**Re: Senary By Allaso/ 7501 Jefferson St NE/PHASE1  
Request for Certificate of Occupancy  
Transportation Development Final Inspection**  
Architect's Stamp dated 06-09-23 (D17D112)  
Certification dated 10-31-25  
TRANS-2025-00311

Re: Traffic Certification for Certification of Occupancy  
Development: Senary by Allaso – Phase 1  
7501 Jefferson St. NE  
Albuquerque, NM 87109

**PHASING PLAN SITE PLAN**

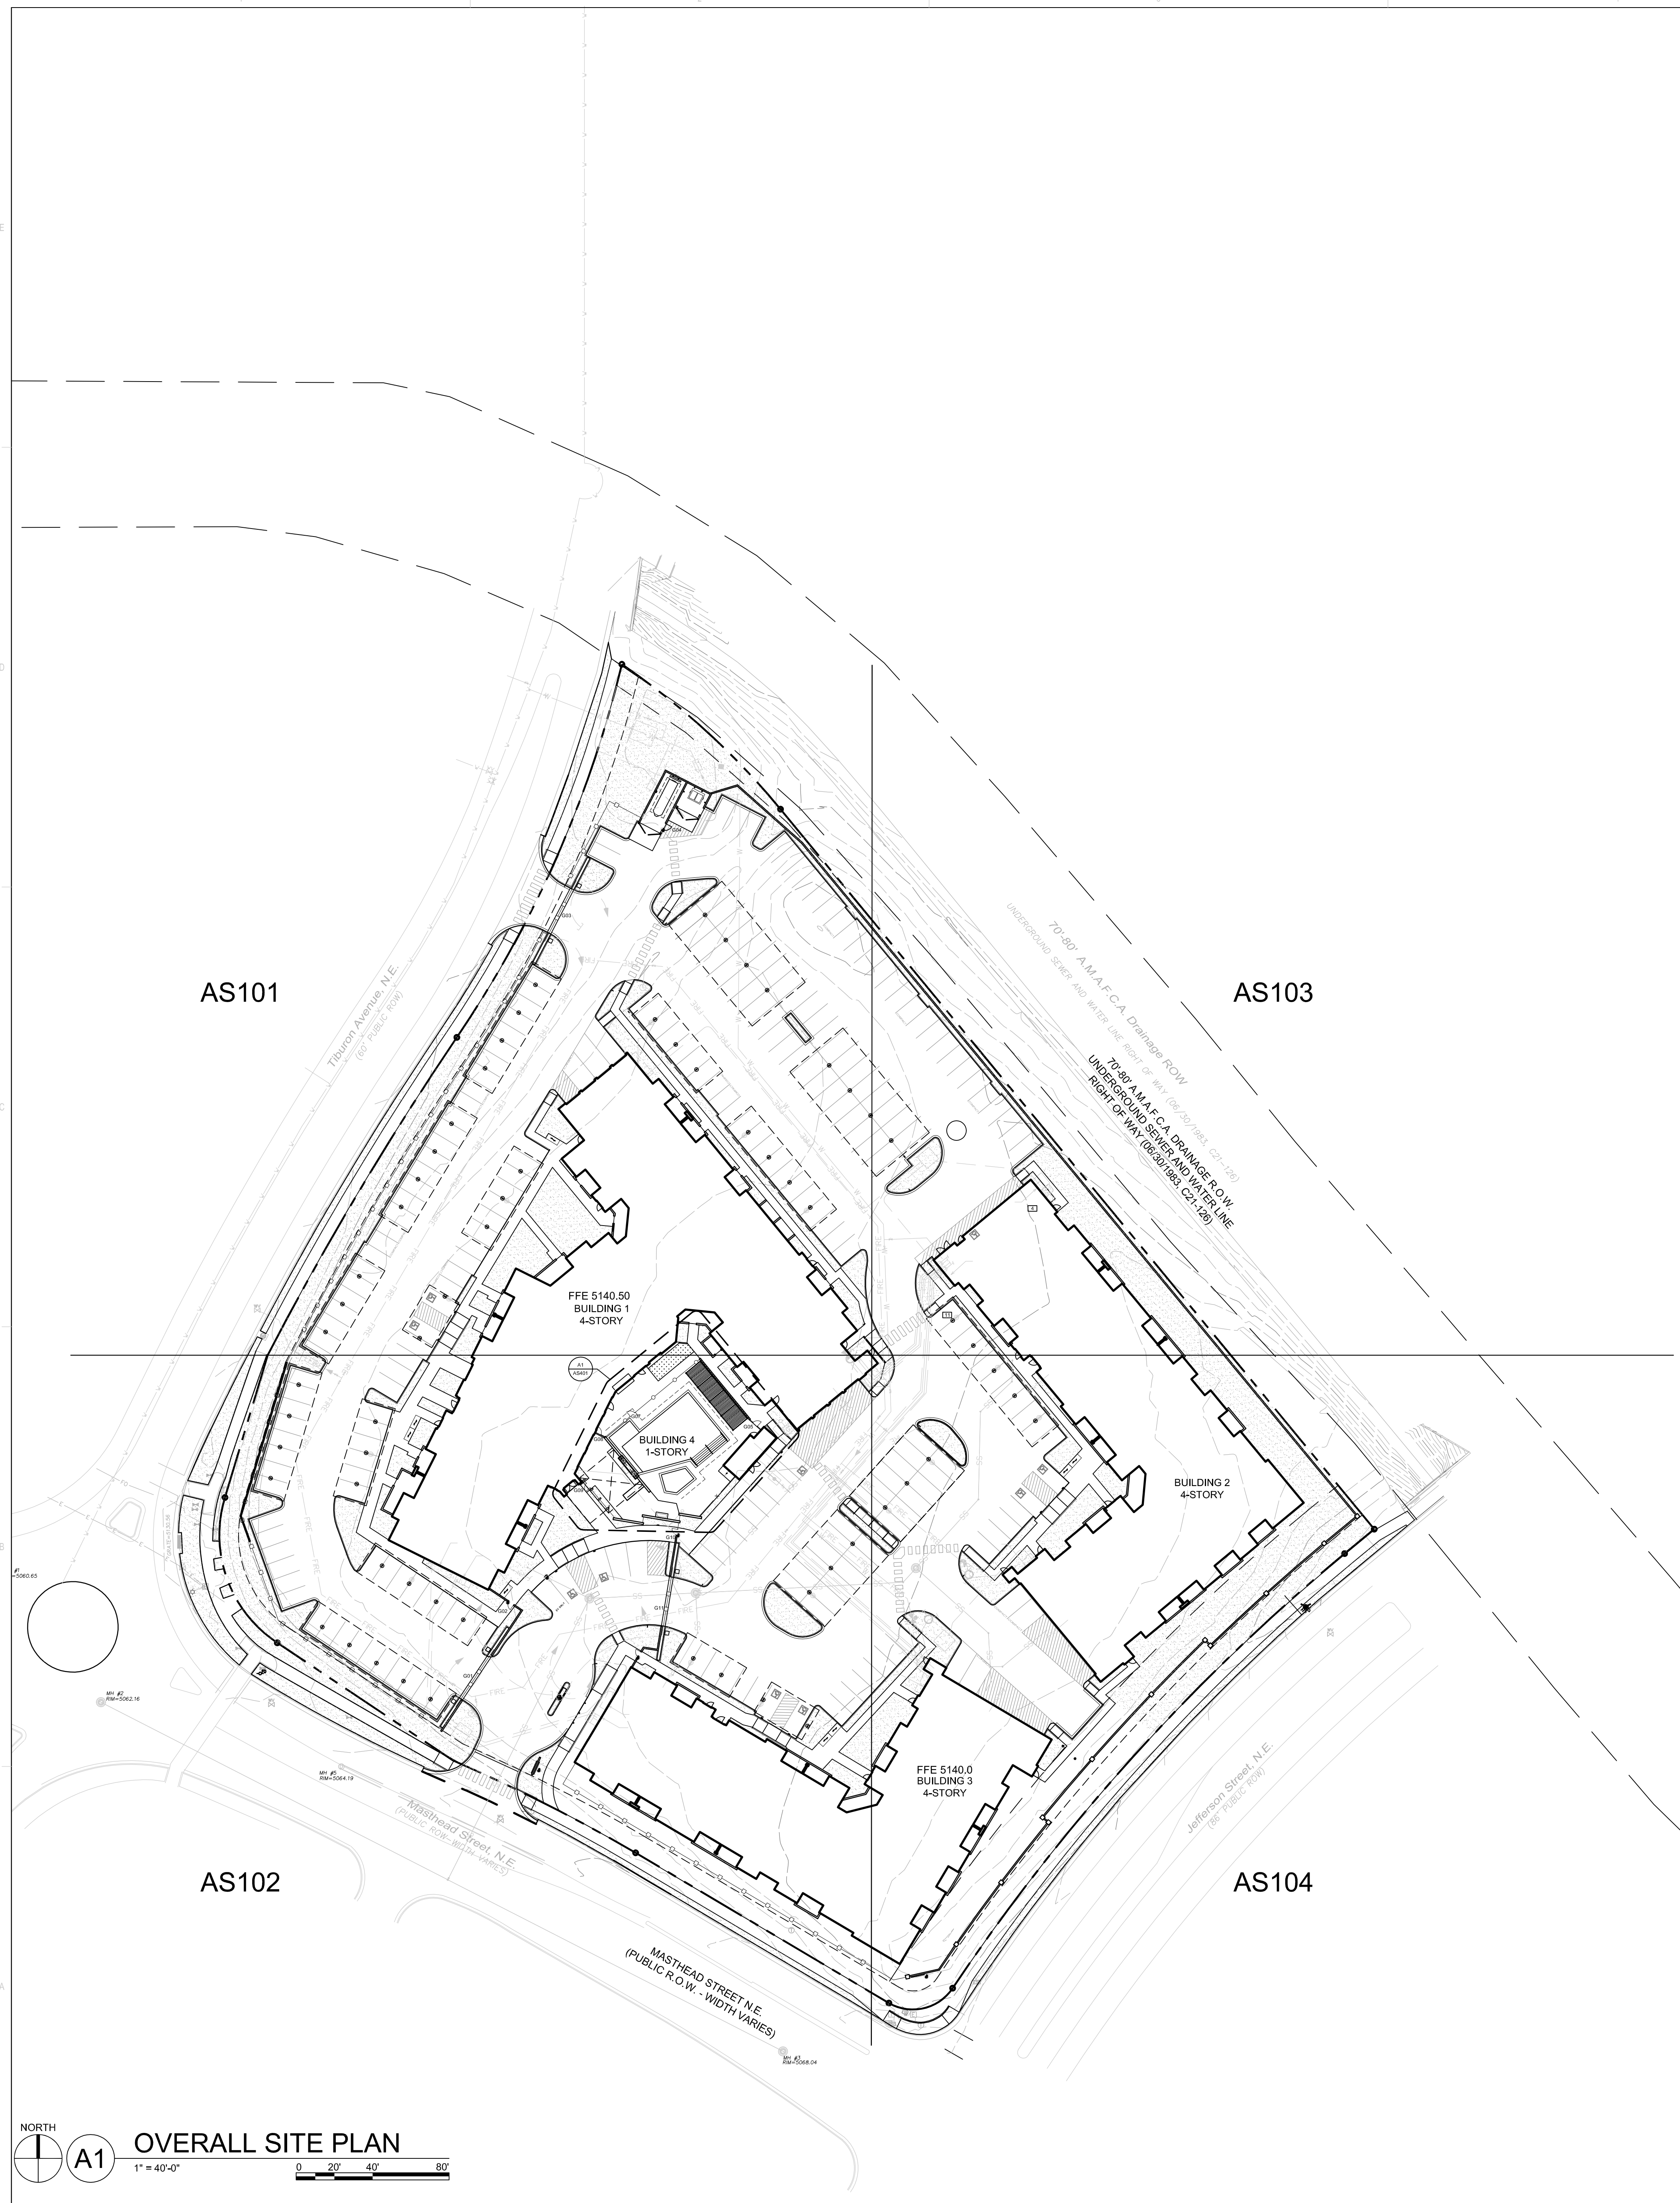
The following items as noted on the attached site plan were identified as incomplete and as such a request for General Contractor / Traffic Inspector field confirmation of completeness and if necessary a request for a deferred approval for 30 days beyond issuance of C of O for Phase 1 for the following items:

There are a few minor pavement striping and signage items that would be considered outstanding at this time: three striped crosswalks, "compact" parking space text, striped no parking area at resident garages, and two bollard-mounted accessible parking signs that should be relocated to head-end of accessible spaces. In addition, two parking spaces had to be eliminated during construction due to proximity of perimeter fencing to the PNM transformer, which was not installed in the correct location. These parking spaces are indicated with a red X on the phasing plan.
